**RESPONSE TO BRISBANE CITY COUNCIL INFORMATION REQUEST: S.13 OF THE *DEVELOPMENT ASSESSMENT RULES***

**DEVELOPMENT PERMIT FOR MATERIAL CHANGE OF USE FOR A MULTIPLE DWELLING OVER LAND AT 14 BOW STREET, YEERONGPILLY (LOT 7 ON RP438281).**

**COUNCIL REFERENCE: A006958827**

# Information Request Response

**Figure 1: Setback diagram which shows minor encroachments to the Acceptable Outcomes (Graham Nottle Architects, 2026)**

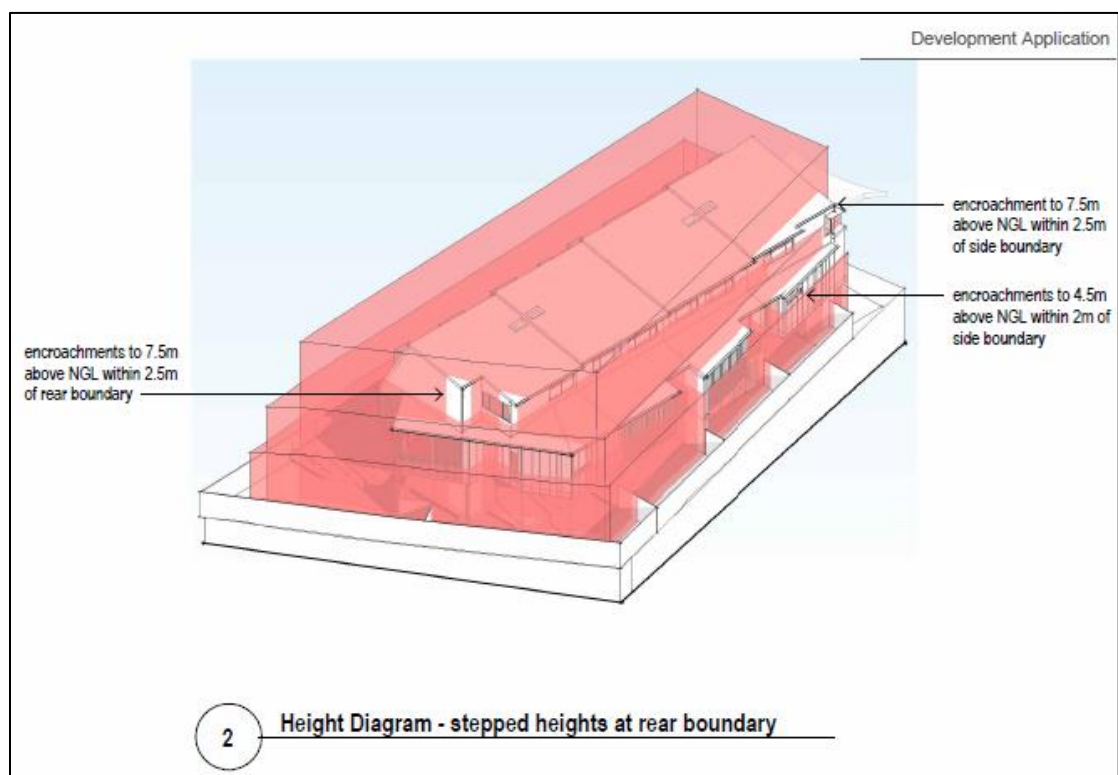
*The proposed building envelope and performance justification against PO3, PO7 and PO14 of the Multiple dwelling code are noted. However, the proposed rear setback of 1.5m to the deck and 2m to the wall and side boundary setback of 1.5m results in a built form that does not minimise the potential impact of the development on the amenity and privacy of the existing adjoining dwellings and their private open space. The proposed design outcome is not considered to reflect the intended form and character of the local area.*

- a) *Submit amended plans increasing the rear boundary setback to both the balcony and wall to be commensurate to the requirements of the assessment benchmarks.*
- b) *Increase the side boundary setbacks commensurate to the requirements of the assessment benchmarks.*
- c) *Increase the side boundary setbacks to the side facing balconies or alter the floor plate to orientate any side facing balconies over the internal driveway to facilitate a greater side boundary setback and building separation.*
- d) *Provide plans detailing the separation distances between the proposal and adjoining buildings with specific identification of separation between balconies and habitable rooms/openings on each property.*

Amended plans are provided in **Attachment B**, which confirm that the proposed layout of the development has been amended to address Council's information request items. In particular, the setbacks to the northern boundary have been amended to provide increased visual interest, increased setbacks to habitable rooms and balconies and as a result, increased privacy and amenity protection for the adjoining neighbouring property. The change in the side boundary setbacks is provided in **Table 1**.

As shown on the height diagram within the revised Architectural Package (refer to **Figure 1**), there are some minor encroachments into the Acceptable Solution requirements under the Multiple Dwelling Code. However, these are limited to blank walls, walls with high windows or decks which have been provided with screening / walls. As such, the revised Architectural Package complies with the Performance Outcome PO3 as the revised design will not impact on the adjoining neighbours' amenity, privacy or overshadowing. Both the setbacks of the subject development and the adjoining neighbouring house will allow natural light and breezes to be maintained.

**Figure 2: Building separation between Unit 1 and adjoining neighbouring dwelling house (Graham Nottle Architects, with measure by Mewing Planning Consultants, 2026)**

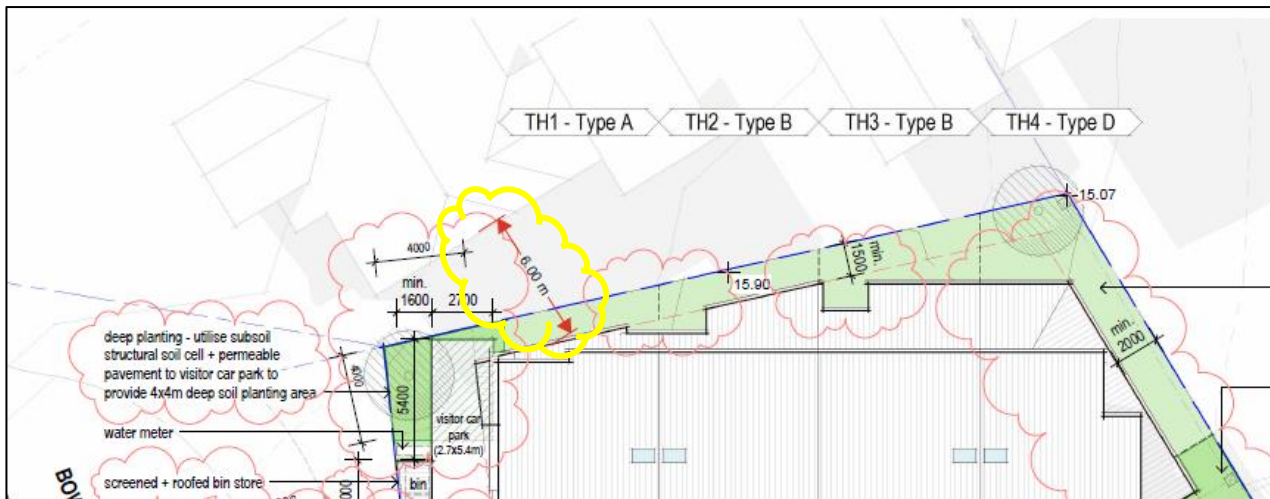
*Further, the proposed side facing balconies for the central units are located close to the side boundary with the inclusion of screening elements. However, this arrangement does not demonstrate that the development maintains the privacy and amenity of adjoining dwelling houses and their private open space and is contrary to the Multiple dwelling code, which anticipates side facing balconies only where for services.*

Furthermore, the proposed units meet the minimum building separation requirements under Table 9.3.14.3.F – Building separation requirements as Unit 1 (closest to Bow Street) has been provided with either blank walls or high windows and is setback a minimum of 6m from the windows of the adjoining neighbouring house (which for this assessment have been assumed to be habitable rooms) (refer to **Figure 2**).

Figure 3: Setback diagram which shows no encroachment to 11.5 metre height (Graham Nottle Architects, 2026)

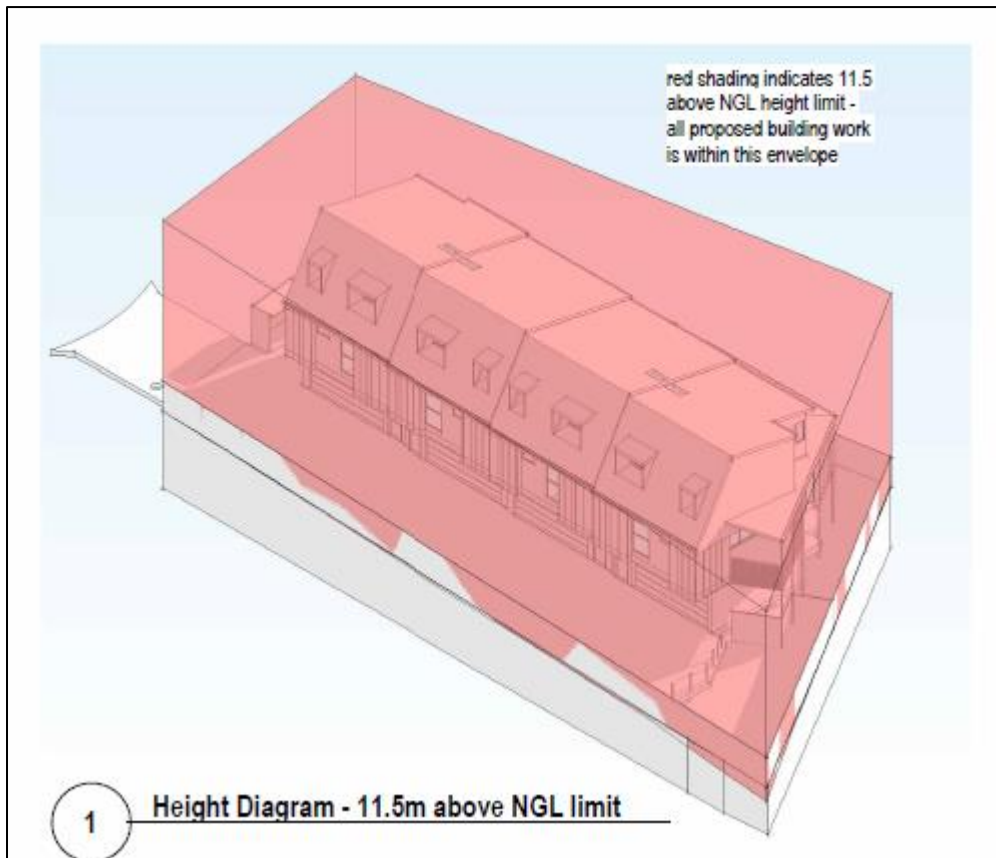
*The proposed South-East elevation plan demonstrates a building height exceeding 11.5m above Natural Ground Level (NGL) at line of building façade and the submitted information indicates that building height is no greater than 11.5m, which is also supported through the side elevations and sections. Provide amended plans demonstrating on all elevations and sections the development does not exceed 11.5m above NGL at any point on the site. The elevations and sections are to include a line of natural ground and a parallel line of 11.5m above this ground level line.*

Amended plans, elevations and sections are provided in **Attachment B** which confirm that the development is below 11.5m in all areas (also refer to **Figure 3**).

**Figure 4: Planting Soil Depth Analysis (Shepherd Urban Landscape Architecture, 2026)**

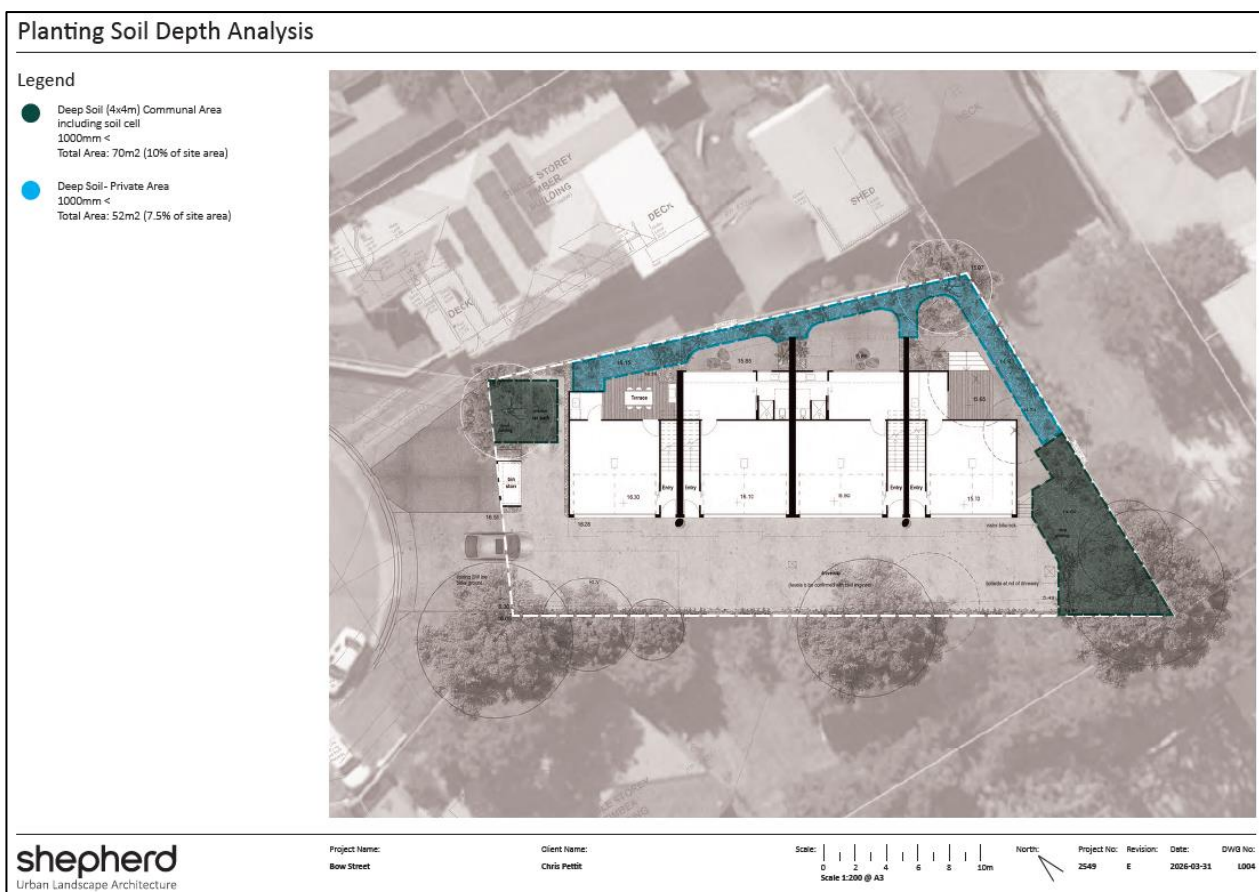
*The deep planting areas must have minimum 4m dimensions to support large subtropical trees. Further, the deep planting areas must be wholly within the subject site, as the plans have demonstrated a 4m dimension inclusive of the verge, and must be kept completely free of underground and above ground services.*

- Provide increased deep planting within the site noting the deep planting provided does not meet the requirements based on the dimensions and inclusion of services.*
- Provide amended plans demonstrating deep planting areas achieve a minimum dimensions of 4m x 4m to accommodate large subtropical trees.*
- Ensure the identified deep planting areas remain free of services and improvement.*

A revised Landscape Concept Plan is provided in **Attachment C**. This provides a planting soil depth analysis (refer to **Figure 4**) which confirms that:

- A total of 70m<sup>2</sup> of deep soil (with a minimum of 4m x 4m) in the communal area, inclusive of a soil cell;
- An additional area of 52m<sup>2</sup> of deep soil in the private recreation space (which does not meet the 4m x 4m measurements), but is still a substantial area of deep planting.

At the site frontage, the deep soil planting has been extended to include a subsoil structural soil cell (CityGreen Stratavault or similar), which extends under the visitor car park slab, including root access into widened verge. As such, the tree at the site frontage will have access to significant tree root areas beyond the surface planting area (between both the soil cell / permeable pavement in the visitor parking space and the wide verge). However, with the inclusion of the soil cell within the site, the development is not reliant upon the verge to provide the 4m x 4m deep planting area.

**Figure 5: Revised Floor Plan - Level 1 (Graham Nottle Architects, 2026)**

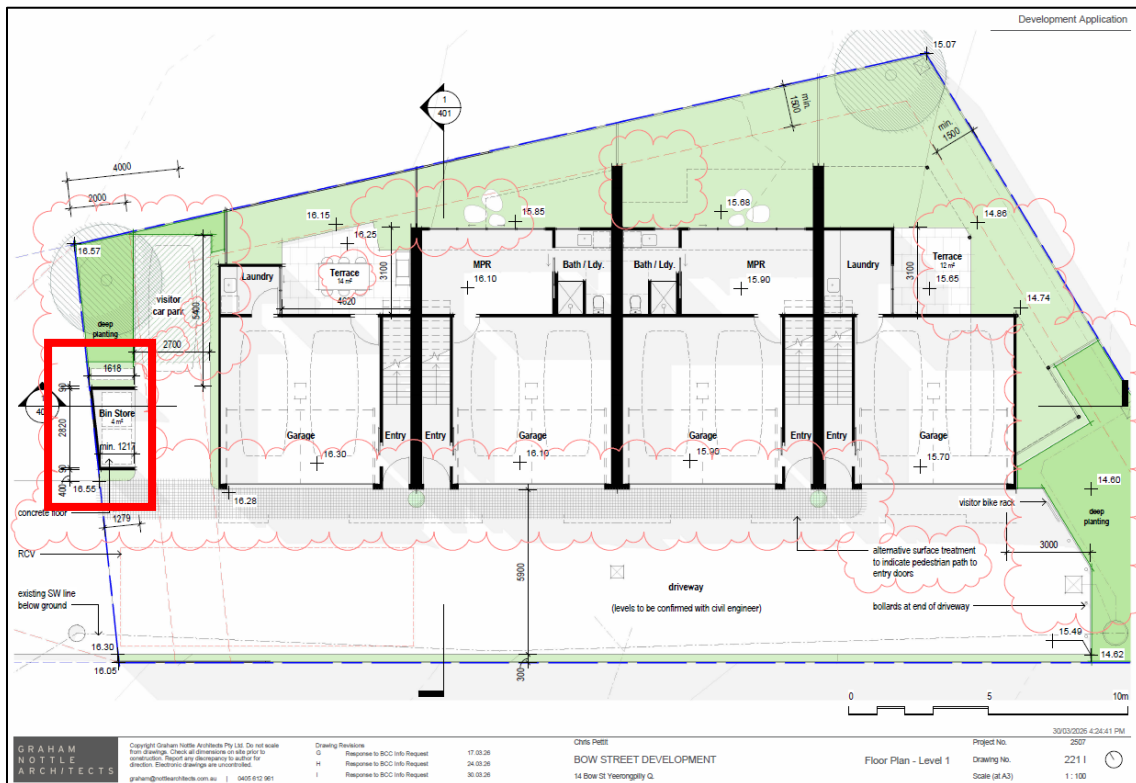
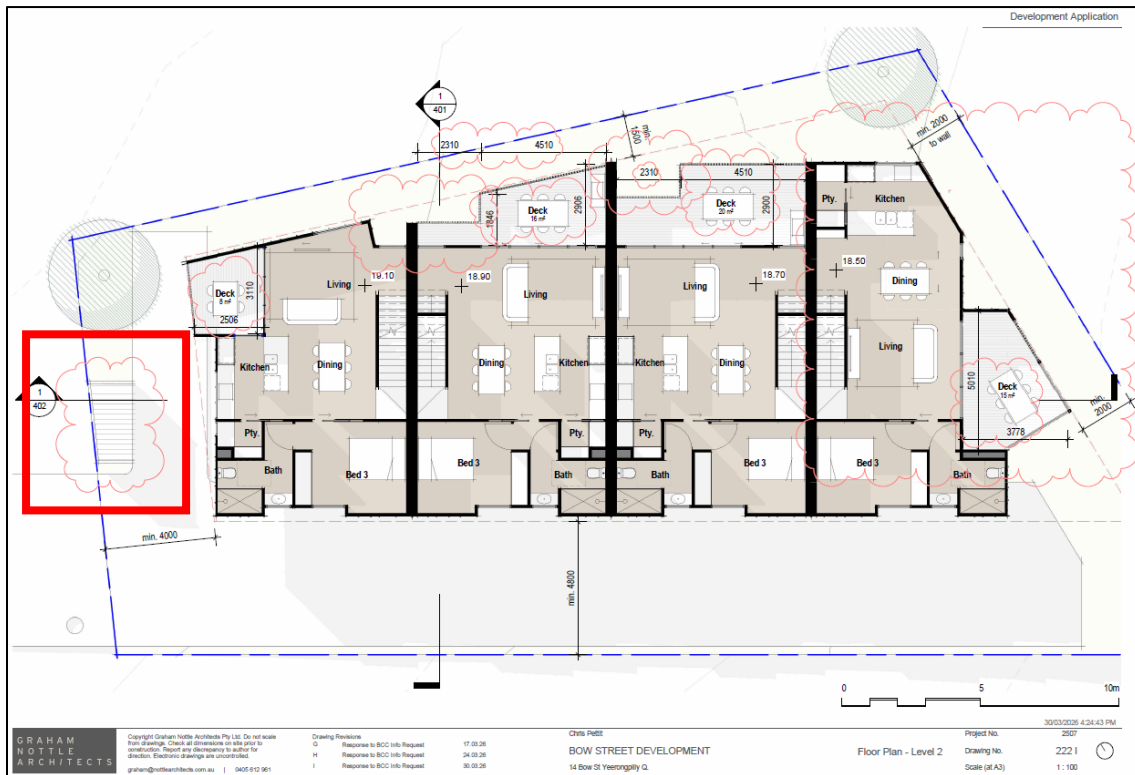
*It is noted that the developments proposed 'Bin Store' provides appears to provide sufficient storage, capacity and source separation for the developments proposed four units. However, the 'Bin Store' has not been denoted as roofed and wholly screened, nor has the GFA and internal dimensions been demonstrated on the plans. In accordance with PO32 of the Multiple dwelling code. Provide amended architectural plans which address the following.*

- a) Demonstrate the 'Bin Store' has been roof and wholly screened.
- b) Clearly show the GFA (m2) and internal dimensions of the 'Bin Store'.

The architectural package has been updated to confirm that the bin store will be both roofed and screened. The architectural plans also confirm that the bin store is 4m<sup>2</sup> in area. Please see Floor Plans – level 1 and level 2, with bin store information highlighted in **Figure 5** and **Figure 6**.

**Figure 7: Vehicle manoeuvring for a refuse collection vehicle (Q Traffic, 2026)**

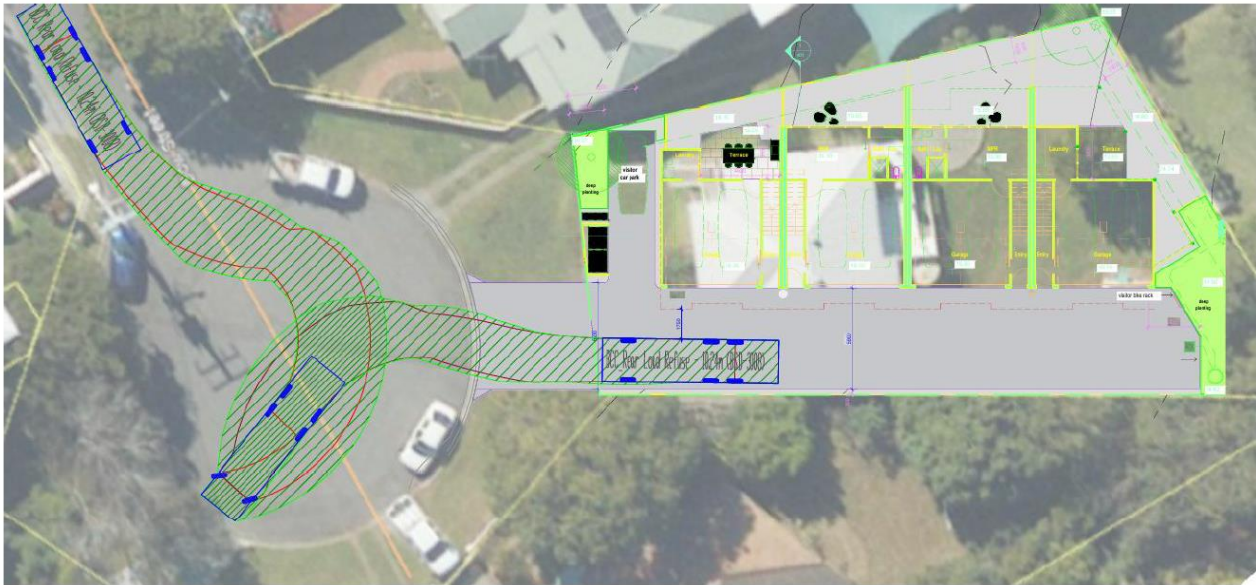
The two-way aisle/carrageeway trafficked by 10.24m rear loading refuse collection vehicle (RCV) is only 5.9 wide in lieu of the required 6.5m. In addition, the driveway crossover is required to be a Type B2, whilst the proposed is 5.6m wide Type B1 crossover. Furthermore, it is noted that level 2 overhangs the two-way aisle/carrageeway trafficked by the RCV and as a result the RCV is not provided a minimum operational clearance of 3.6m across the entire aisle. In accordance with PO32 and of the Multiple dwelling code, PO8 of the Infrastructure design code and PO1 and PO19 of the Transport, access, parking and servicing code, demonstrate the following.

- Provide amended plans which demonstrates a minimum 6.5m wide two-way aisle carrageeway trafficked by the RCV in accordance with Table 12 of the TAPS PSP.
- Provide amended plans demonstrating a 6.5m wide Type B2 crossover.
- Provide amended plans which clearly demonstrates the RCV standing/loading area have been provided with a minimum vertical operation clearance of 3.6m between the Ground FFL and lowest projection above, for the entire 6.5m wide aisle/carrageeway for a length of 11.5m

As indicated in the Traffic Response provided by Q Traffic (refer to **Attachment D**), an alternate solution to the standard Type B2 crossover for the following reasons:

- The site is located at the end of a cul-de-sac, **not** mid-block on a constrained residential street.
- The cul-de-sac has a diameter of approximately 23m;
- This provides substantial manoeuvring area external to the site.

As demonstrated in the swept path (refer to **Figure 7**), the RCV is able to:

- Enter the cul-de-sac;
- Manoeuvre within the turning head; and
- Align with the site access without requiring tight 90-degree turning movements.

Accordingly, the Type B2 flares serve no functional purpose in this context.

Figure 9: Revised Preliminary Bulk Earthworks Plan (Create Engineers, 2026)

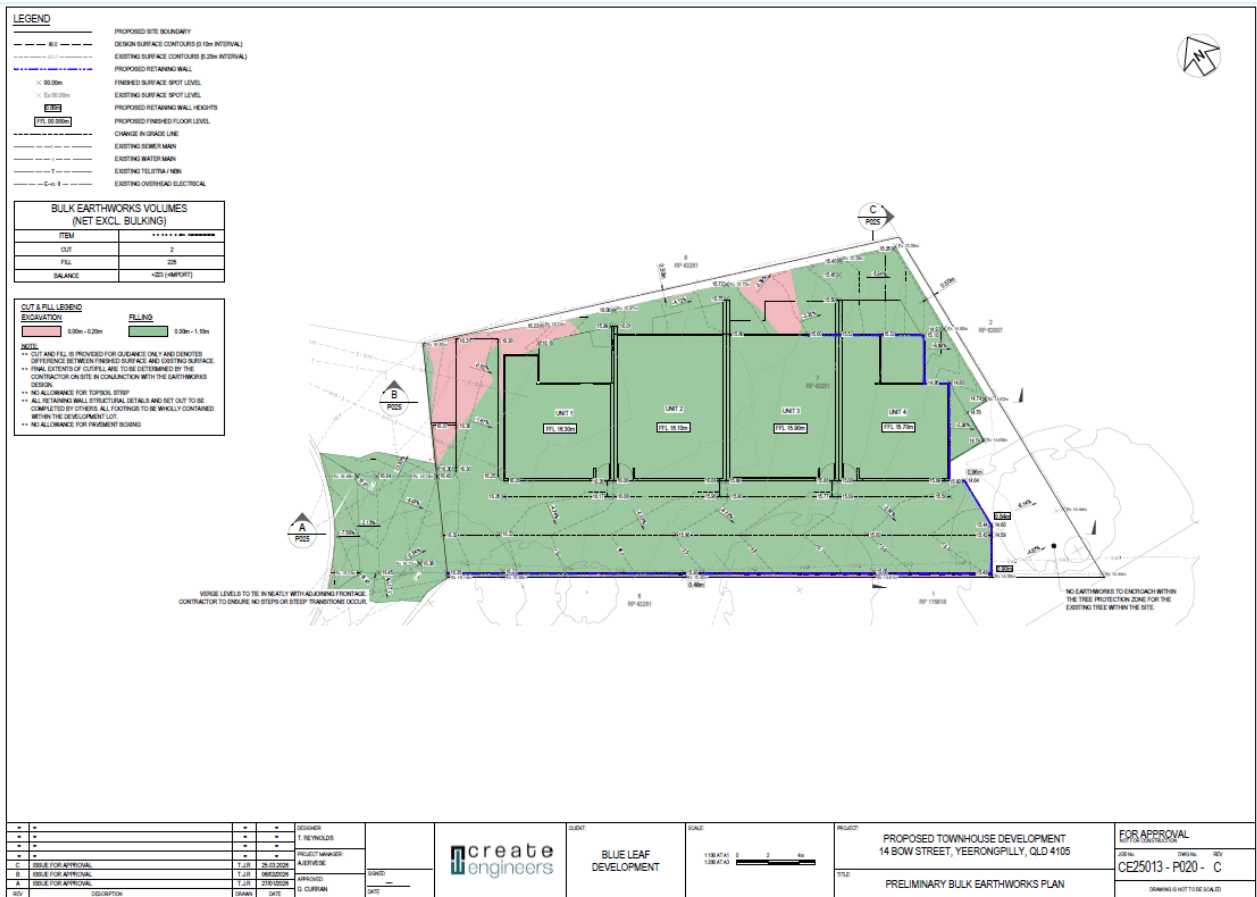
*The proposed earthworks plan shows filling located on the site's boundaries. This placement may alter the natural surface flow paths in a major storm event and create a concentration of sheet flow onto adjoining properties, contrary to PO2 of the Stormwater code which requires development to ensure that site works do not adversely impact flooding or drainage characteristics of adjacent premises.*

- a) Amend the earthworks plan to show all filling along the northern and eastern boundary set back a minimum of 500mm from the boundary to ensure sheet flow remains contained within the site and does not concentrate onto neighbouring properties.*

A Civil Engineering Technical Memorandum (refer to **Attachment E**) has been prepared, which states that the proposed earthworks have been offset 500mm from the northern and eastern property boundaries (refer to **Figure 9**).

Detailed earthworks will be completed as part of the detailed design phase of the development. The design and construction of earthworks will be in accordance AS3798. This can be reasonably and relevantly conditioned as part of an approval.

Figure 10: Preliminary Services Plan (Create Engineers, 2026)

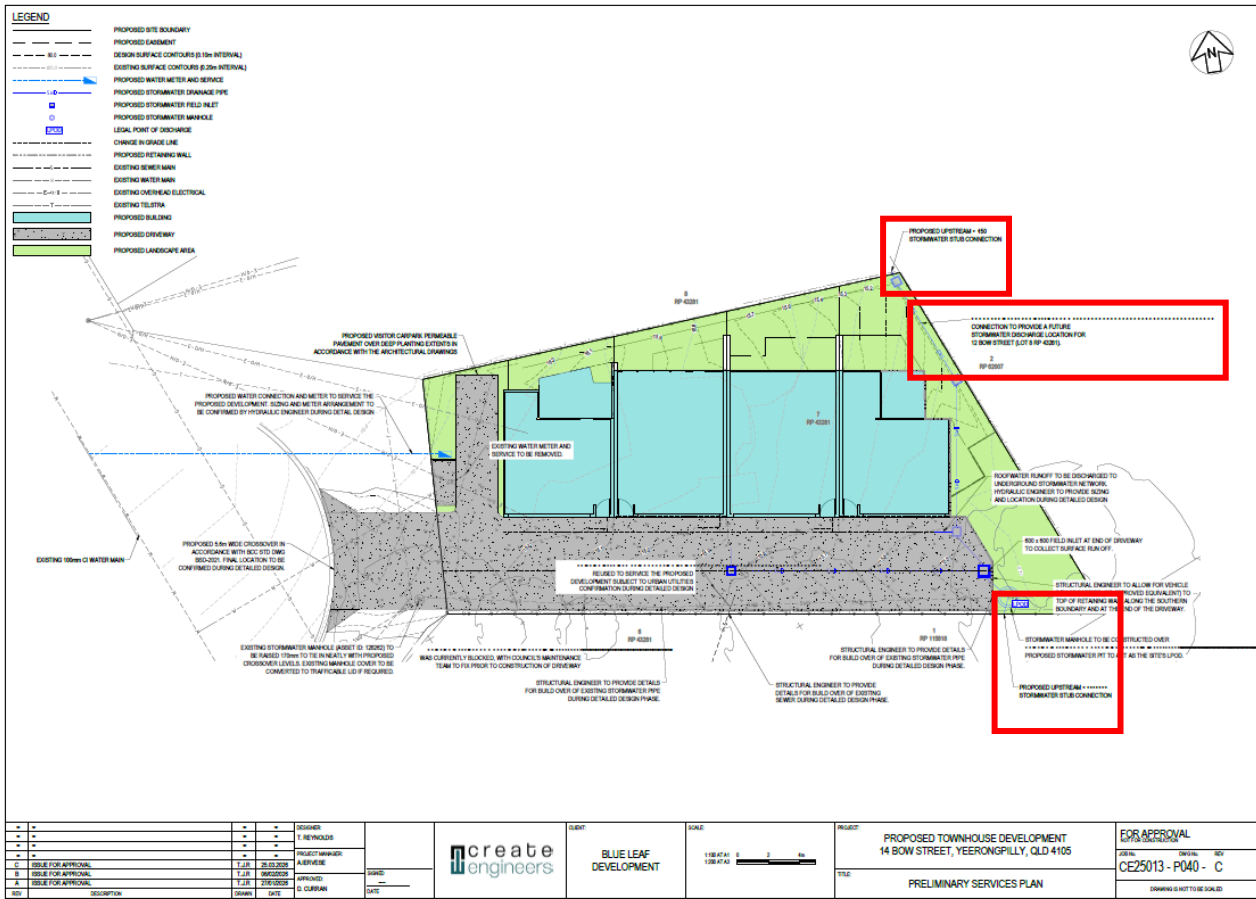
The proposed development provides an upstream stormwater connection for Lot 8 on RP43281. However, a further connection should also be provided for Lot 6 on RP43281. Provide amended plans detailing this additional upstream connection.

The Civil Engineering Technical Memorandum has been prepared and is attached in **Attachment E**. This includes three stormwater connections to others, which are highlighted in red boxes on **Figure 10**. The revised design includes a new proposed connection along the southern boundary in response to Council's information request.
